Indian Point Energy Center Corrective Actions for Generic Letter 2004-02

Enclosure

Figure 5: Initial Debris Bed Poured in Loop 1

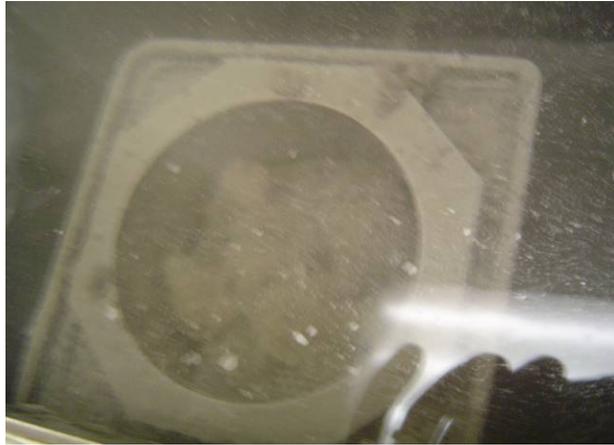
While the debris bed was being formed in Loop 1, flow through the loop was observed to drop to zero. The vendor stated that this flow stoppage was likely due to debris blockage at a throttle valve in the test loop. The apparent blockage at the throttle valve resulted in at least the upper layers of the debris bed being formed by gravity alone, as opposed to the flow through the test screen. A negligible head loss was measured following the formation of this debris bed, which is shown below in Figure 5.

The vendor then prepared a debris slurry representing a different loading condition for Loop 2 and poured it onto the test screen. The measured head loss after bed formation registered a small increase, but did not appreciably rise above zero. No flow anomalies were detected during the pouring of the debris bed. The staff noted that the fiber in the debris bed was unexpectedly fluffy and porous, although the frequency of agglomerated clumps of debris appeared lower than for the Loop 1 bed.

Figure 12: Test Tank Filled With Coupons and Sample Baskets

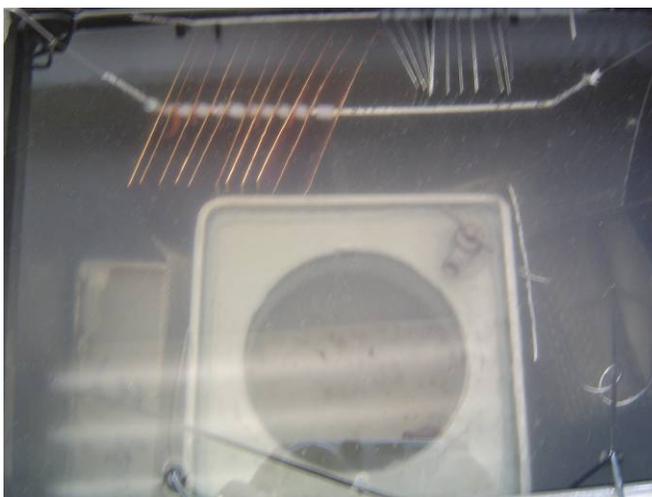
In addition, the scaling factors associated with several of the IP tests observed by the staff required a significant number of sample baskets and metallic coupons, which filled a substantial fraction of the available test tank volume. Stacked or closely spaced baskets have the potential to limit further the interaction of the test fluid with the sample materials in the baskets. In addition, the staff observed in one test that a sample coupon was inserted in the test tank with one side very close or adjacent to the wall of the test tank, which appeared to prevent appreciable flow of the test fluid to approximately half of the coupon surface area. All of these issues are tied to the staff's larger concern that the sample materials added to the test tank may not be able to interact with the test fluid in a representative manner. As a result, fewer chemical species could be dissolved into the test fluid, and, therefore, there may be a non-representative reduction in the potential for formation of chemical precipitates in the VUEZ test loop. Figure 12, below, shows a test tank filled with closely spaced coupons and sample baskets.

For the IP tests observed by the staff, care was taken to thoroughly mix the tank fluid by mechanical mixing after the addition of the boric acid. This mixing was done because, as VUEZ personnel indicated during the staff's visit, it can take longer than 4 hours to completely mix the fluid in the test tank. This same procedure was not used when the buffer, hydrochloric and nitric acids, and the last portion of lithium hydroxide were subsequently added to the test. The lack of mixing following the addition of these latter chemicals was due in part to the inability to get a mechanical mixer into the tank due to physical limitations caused by the volume being taken up by coupons and baskets of material in the tank at the time of the latter additions. The mixing of these chemicals into the bulk fluid would take longer than the initial addition of boric acid due to the complex geometries and uneven flow zones created by the coupons and baskets. The reason this issue is a potential concern to the staff is that the timed removal of coupons and baskets in the test protocol (some of which may be removed only 50 minutes into the test) was based on the expected time the samples would have to interact with the chemicals in the test fluid. If the chemicals are not well mixed with the test fluid, then the coupons and baskets may
